# Access Compliance Report

## Public Rights-of-Way

Intersection ID: 47396	Main Street: FLAT_RIVER_DR	Cross Street: FLAT_RIVER_DR	Location:	N
ADA ID: B6CCECB16BA2	Ramp Type: Perp	Initial Pass/Fail: Fail	Overall Compliance: No	Severity Score: 12.5

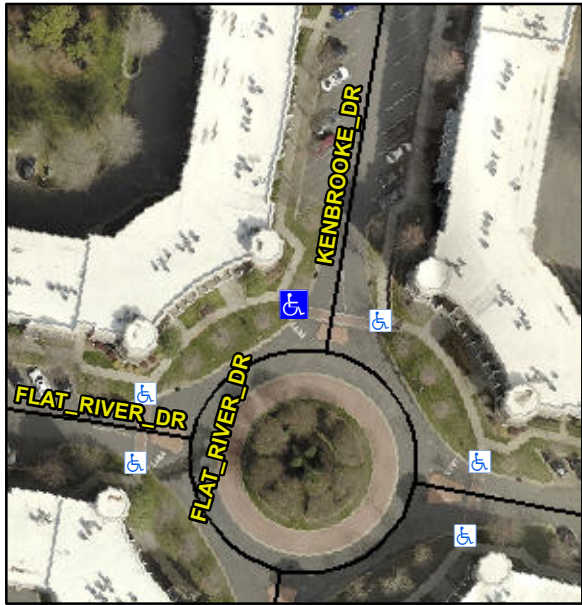
Codes/Mitigation Info/Possible Solution			Field Measurements/Component Compliance					
	Possible Solutions:		<b>Compliance</b>	<b>Description</b>	<b>Data</b>	<b>Compliance</b>	<b>Description</b>	<b>Data</b>
	<b>Remove &amp; Replace Entire Ramp.</b>		N/A	Ramp Length (in)	58.5	No	Ramp Slope (%)	8.7
			Yes	Ramp Width (in)	48.0	Yes	Ramp XSlope (%)	1.7
			N/A	Flare Type LT	N/A	N/A	Flare Type RT	N/A
			N/A	Flare Slope LT (%)	N/A	N/A	Flare Slope RT (%)	N/A
			N/A	Flare Traversable LT?	N/A	N/A	Flare Traversable RT?	N/A
			N/A	Landing Length (in)	N/A	N/A	DWS Provided?	N/A
			N/A	Landing Width (in)	N/A	N/A	DWS Contrast?	N/A
			N/A	Landing Slope (%)	N/A	N/A	DWS Length (in)	N/A
			N/A	Landing X Slope (%)	N/A	N/A	DWS Full Width?	N/A
Surveyor Notes:	<b>N/A</b>		N/A	Landing Curb? (Y/N)	N/A	N/A	DWS Offset (in)	N/A
			N/A	Shared Landing?	N/A			
			N/A	Gutter Ponding?	N/A	N/A	Gutter Slope (%)	N/A
			N/A	Gutter Lip Ht (in)	N/A	N/A	Gutter X Slope (%)	N/A

N/A	Painted X Walk1?	Yes	N/A	Painted X Walk2?	N/A
				X Walk 1 Direction	To E		X Walk 2 Direction	N/A
			N/A	X Walk 1 Width (in)	51.0	N/A	X Walk 2 Width (in)	N/A
				X Walk 1 Slope (%)	6.7		X Walk 2 Slope (%)	N/A
				X Walk 1 X Slope (%)	6.0		X Walk 2 X Slope (%)	N/A
			N/A	Ramp inside XWalk1?	Yes	N/A	Ramp inside XWalk2?	N/A
PROW/ADA:	<b>R304.2.2</b>			Road Slope (%)	N/A	N/A	Clear Space?	N/A
				Road X Slope (%)	N/A	N/A	Clear Space to XWalk (in)	N/A
			N/A	Any Obstructions?	N/A	N/A	Storm Grate/Utility Hazard?	N/A
				Obstruction Type			Storm Grate/Utility Type	
						N/A		N/A
						Yes	Surface Condition? (G/P)	Good
	Total Cost:		\$	1850.00
